Access Compliance Report

Public Rights-of-Way

(Curb Ramps)

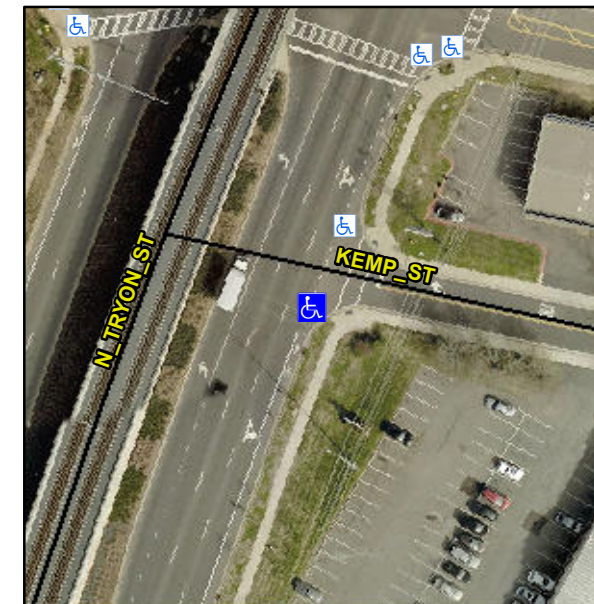
Not Found, R304.5.1, R304.5.3

Compliance	Description	Data	Compliance	Description	Data
N/A	Ramp Length (in)	71.0	Yes	Ramp Slope (%)	7.1
No	Ramp Width (in)	46.0	No	Ramp XSlope (%)	3.9
N/A	Flare Type LT	N/A	N/A	Flare Type RT	N/A
N/A	Flare Slope LT (%)	N/A	N/A	Flare Slope RT (%)	N/A
N/A	Flare Traversable LT?	N/A	N/A	Flare Traversable RT?	N/A
N/A	Landing Length (in)	N/A	N/A	DWS Provided?	N/A
N/A	Landing Width (in)	N/A	N/A	DWS Contrast?	N/A
N/A	Landing Slope (%)	N/A	N/A	DWS Length (in)	N/A
N/A	Landing X Slope (%)	N/A	N/A	DWS Full Width?	N/A
N/A	Landing Curb? (Y/N)	N/A	N/A	DWS Offset (in)	N/A
N/A	Shared Landing?	N/A			
N/A	Gutter Ponding?	N/A	N/A	Gutter Slope (%)	N/A
N/A	Gutter Lip Ht (in)	2.5	N/A	Gutter X Slope (%)	N/A
N/A	Painted X Walk1?	Yes	N/A	Painted X Walk2?	N/A
	X Walk 1 Direction	To NE		X Walk 2 Direction	N/A
N/A	X Walk 1 Width (in)	118.0	N/A	X Walk 2 Width (in)	N/A
	X Walk 1 Slope (%)	4.1		X Walk 2 Slope (%)	N/A
	X Walk 1 X Slope (%)	4.8		X Walk 2 X Slope (%)	N/A

Remove & Replace Entire Ramp.
